MIL-M-38510/344
AMENDMENT 2
16 November 1992
SUPERSEDING
AMENDMENT 1
24 February 1987

MILITARY SPECIFICATION

MICROCIRCUITS, DIGITAL, BIPOLAR, ADVANCED
SCHOTTKY TTL, DECADE COUNTERS, MONOLITHIC SILICON

FIGURE 5. Switching time test circuit and waveforms for device type 03 - Continued.

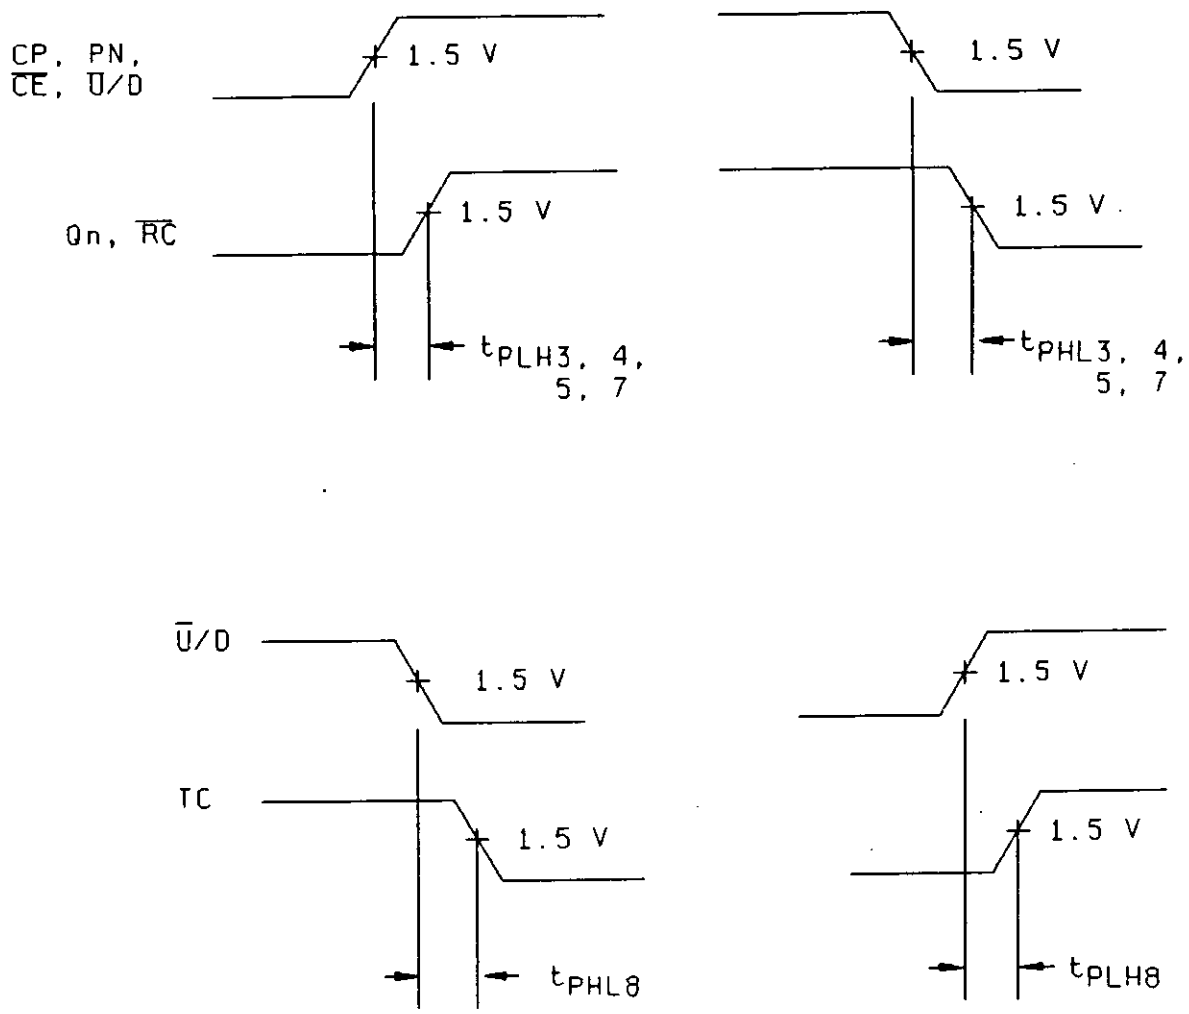
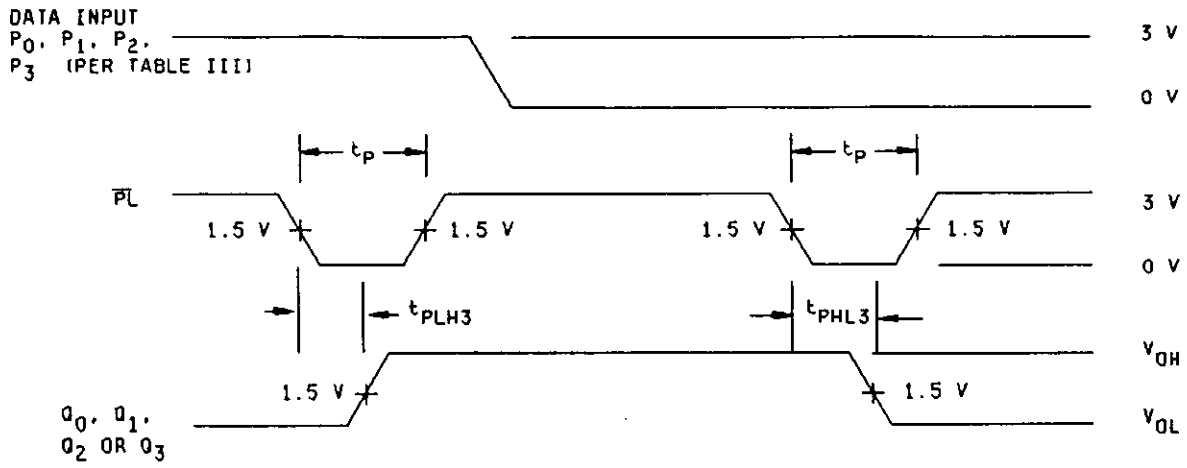
FIGURE 5, directly below clock: Delete "t_{PLH}" and substitute "t_{PLH1}".
